**Placer County Office of Education**

HVAC Package Unit Replacement

**ADDENDUM NO. 1**

Tuesday, May 26, 2025

**A** DEMOLITION PLUMBING ROOF PLAN  
SCALE: 3/32" = 1'-0"

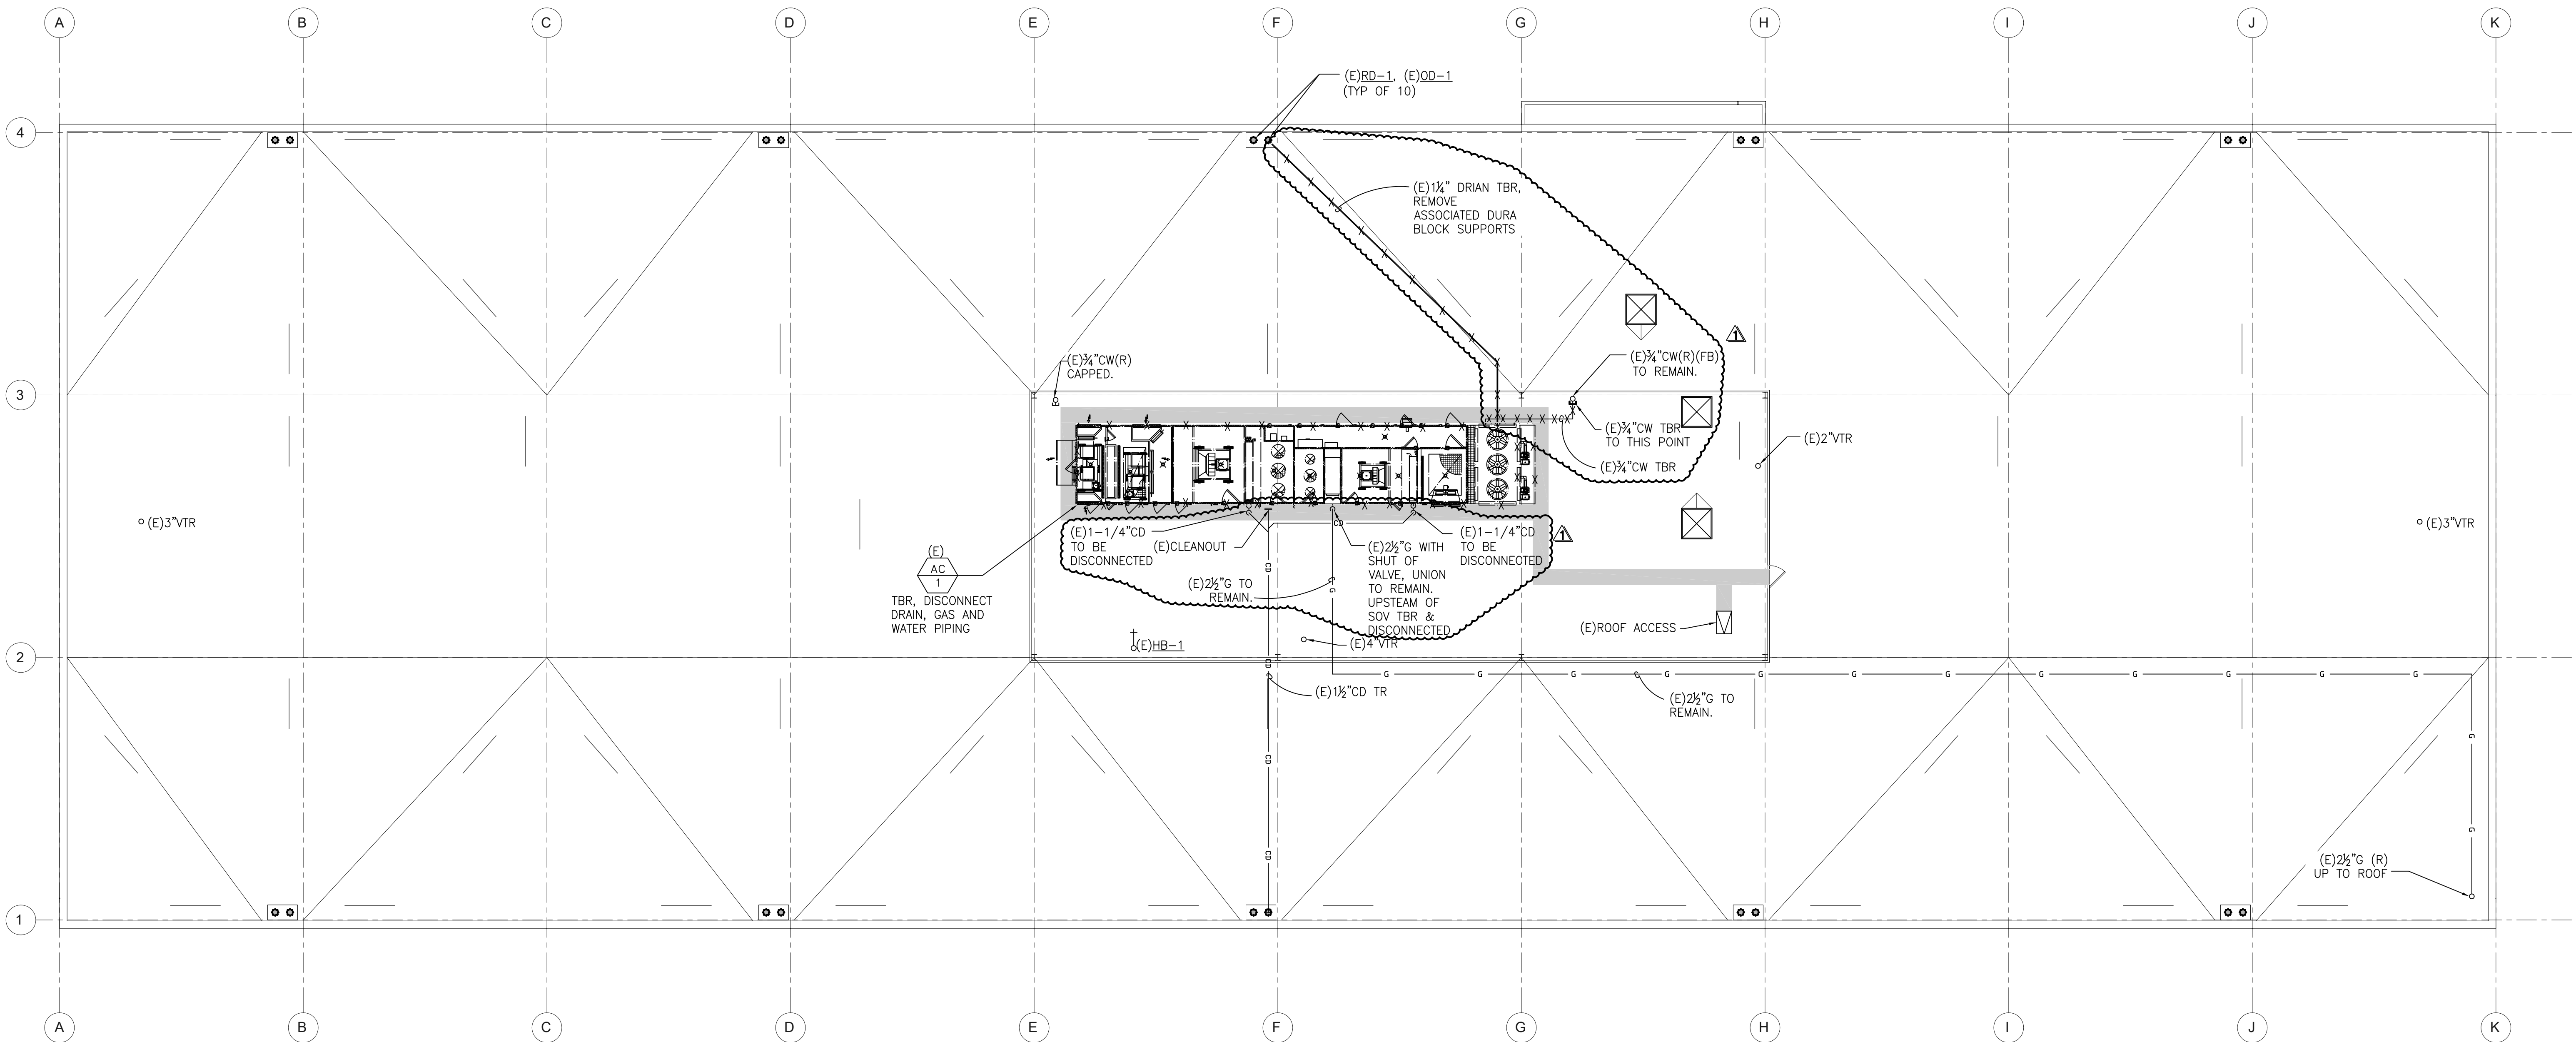
6. Sheet P3.11
  - a. **REVISE:** Detail A/P3.11 to correctly show condensate drain routing and demolition scope of work for the condensate drain and sump drain. Demolition work of the cold water piping was clarified and limited to the above roof.

- b. **REVISE:** Detail B/P3.11 to show gas piping demolition on the correct side of the unit.
7. Sheet P3.21
  - a. **REVISE:** Detail A/P3.21 to clarify the condensate drain connection and the gas connection to the unit.

1 ROOF PLAN - DEMOLITION ELECTRICAL  
E2.10 SCALE: 3/32" = 1'-0"

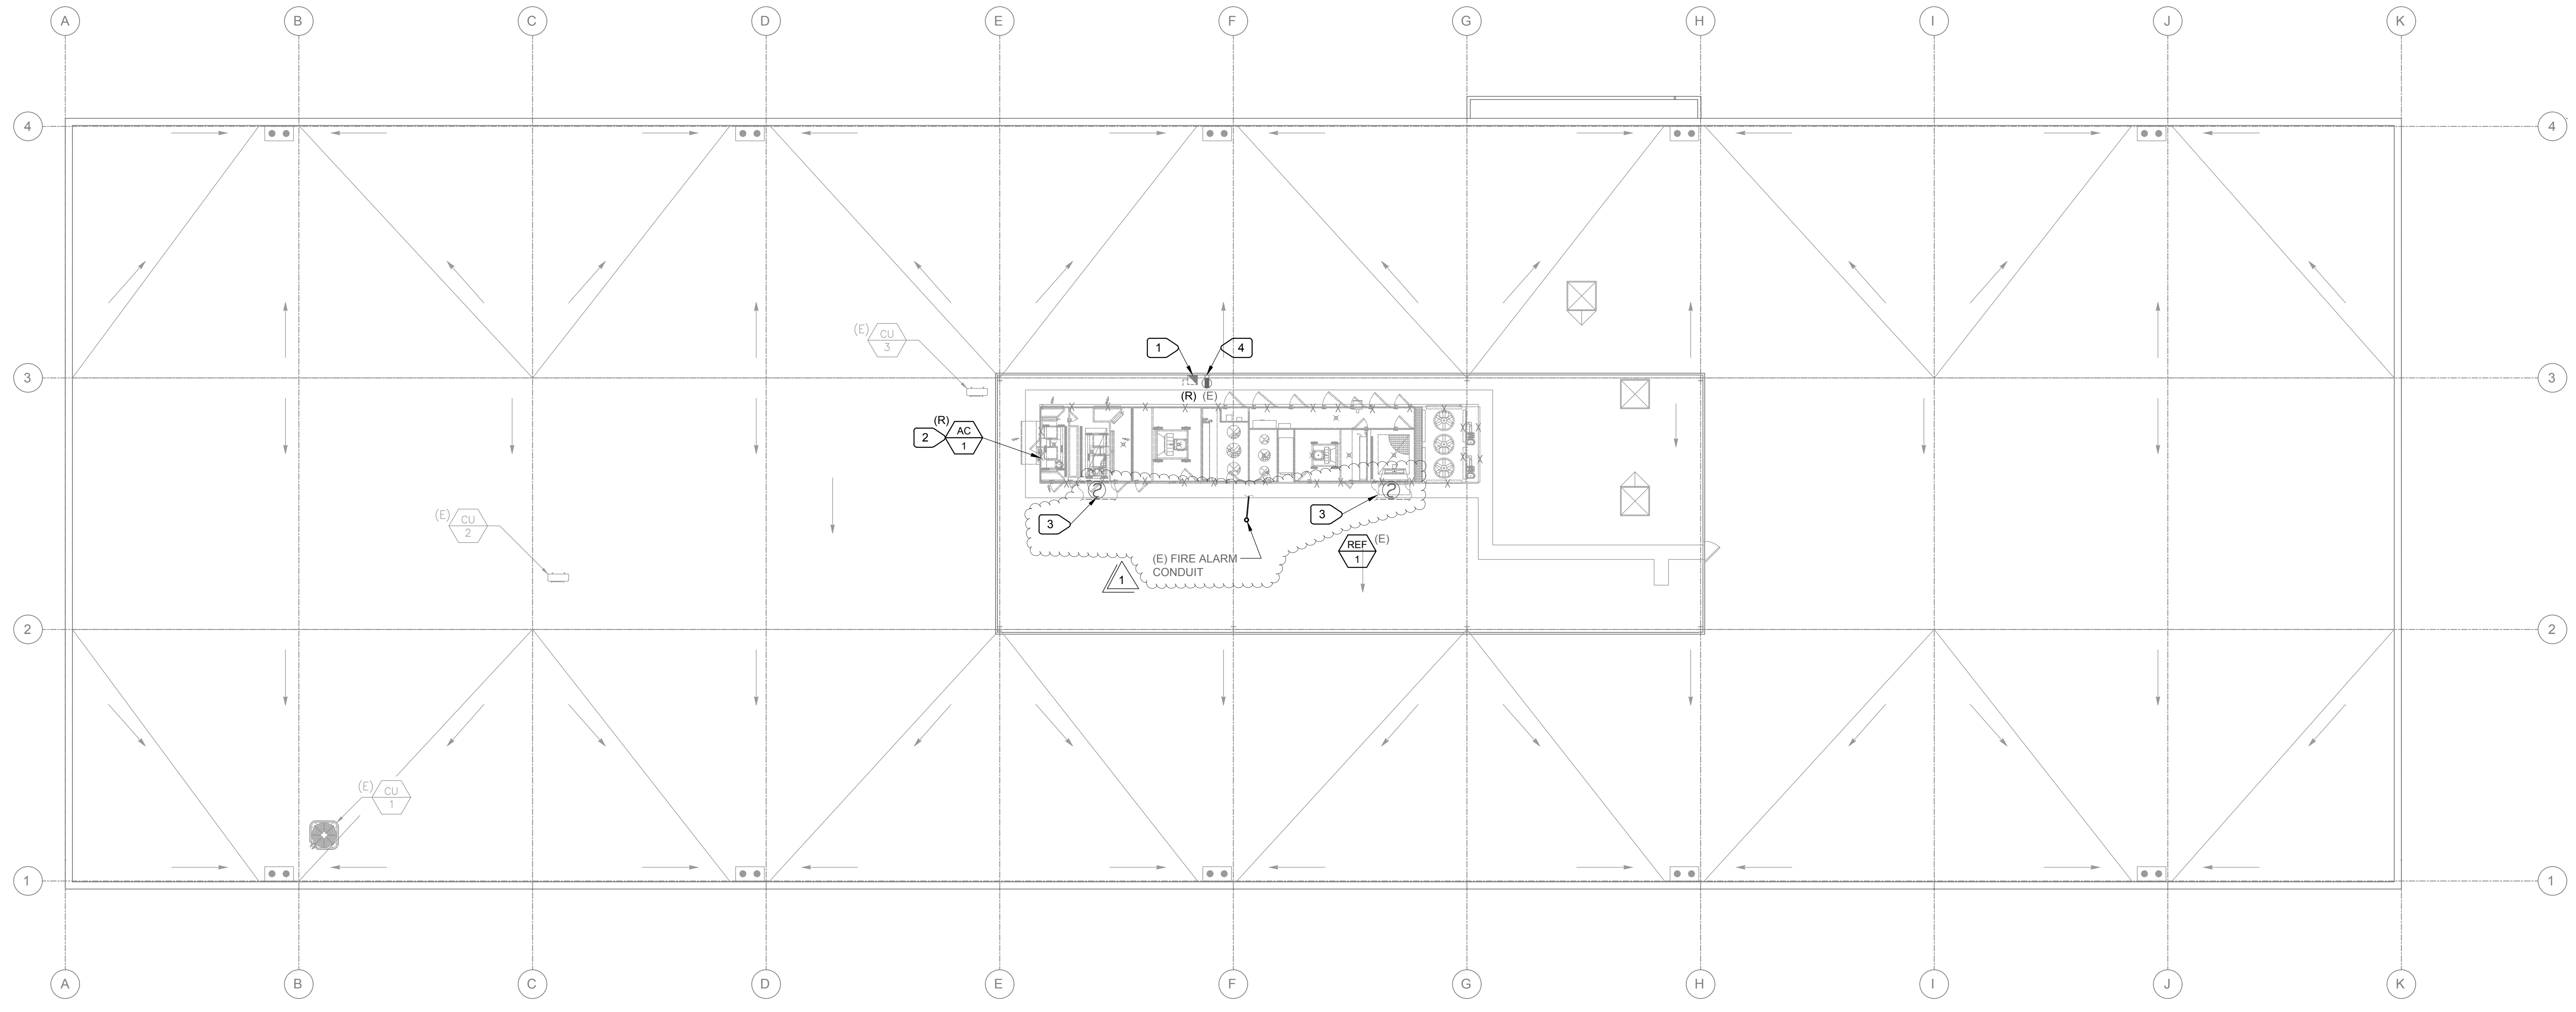
8. Sheet E2.10:
  - a. **REVISE:** Numbered Note 3.
  - b. **REVISE:** "Roof Plan – Demolition" to show existing duct detectors in existing locations.
  - c. **REVISE:** "Roof Plan – Demolition" to show location of existing fire alarm conduit.

- 1 DISCONNECT AND REMOVE EXISTING DISCONNECT SWITCH. REMOVE EXISTING CONDUCTORS BACK TO MAIN SWITCHBOARD. PROTECT EXISTING CONDUITS TO MAIN SERVICE SWITCHBOARD FOR REUSE.
- 2 DISCONNECT AND REMOVE EXISTING CONDUCTORS AND CONDUIT BACK TO EXISTING DISCONNECT SWITCH.
- 3 LOCATE AND DISCONNECT EXISTING DUCT SMOKE DETECTORS AND SAMPLING TUBES. PROTECT EXISTING FIRE ALARM INITIATION CIRCUIT FOR RECONNECTION TO NEW DUCT DETECTORS. COORDINATE WITH FIRE ALARM CONTRACTOR.
- 4 EXISTING RECEPTACLE TO REMAIN. PROTECT DURING CONSTRUCTION.

1 ROOF PLAN - REMODEL ELECTRICAL  
 E2.11 SCALE: 3/32" = 1'-0"

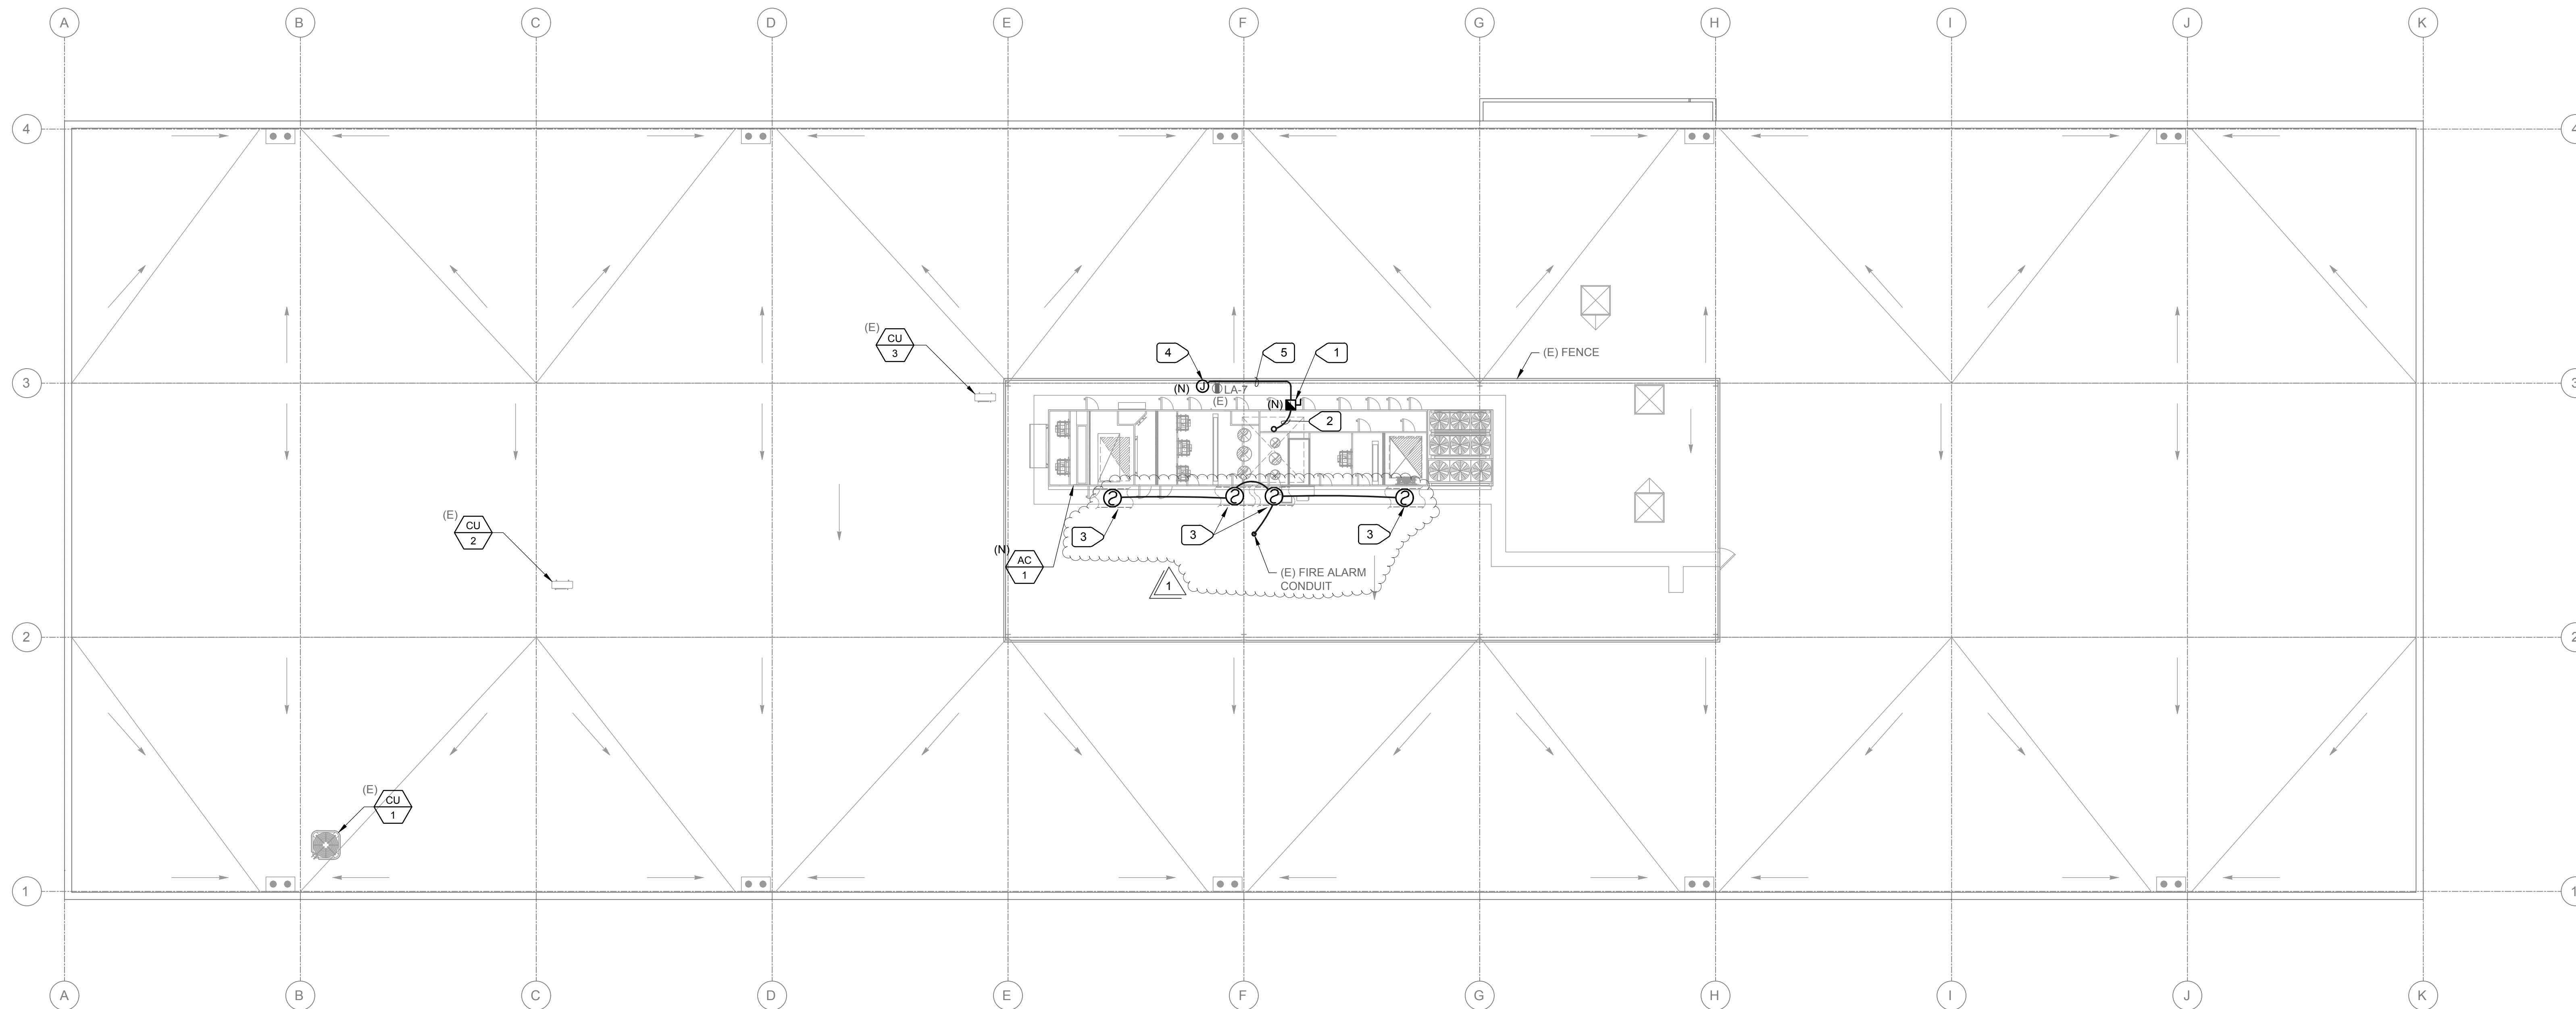
9. Sheet E2.11:
  - a. **REVISE:** Numbered Note 3.
  - b. **REVISE:** "Roof Plan – Electrical" to show (2) additional duct detectors per Mechanical drawings.

- c. **REVISE:** "Roof Plan – Electrical" to show location of existing fire alarm conduit.

- 3 NEW DUCT DETECTORS PROVIDED BY HVAC MANUFACTURER. LOCATE (E) FIRE ALARM INITIATION LOOP. EXTEND TO NEW DUCT SMOKE DETECTORS AND CONNECT. PROVIDE MONITOR MODULES AS NECESSARY TO ENSURE COMPATIBILITY OF NEW DUCT DETECTORS WITH EXISTING FIRE ALARM SYSTEM. FIRE ALARM SYSTEM SHALL BE REPROGRAMMED AS REQUIRED TO ACTIVATE DUCT DETECTORS. PROVIDE TERMINAL BLOCK IF EXISTING FIRE ALARM WIRING IS NOT LONG ENOUGH TO REACH NEW DETECTOR LOCATIONS. SPLICES ARE NOT ALLOWED IN FIRE ALARM WIRING.
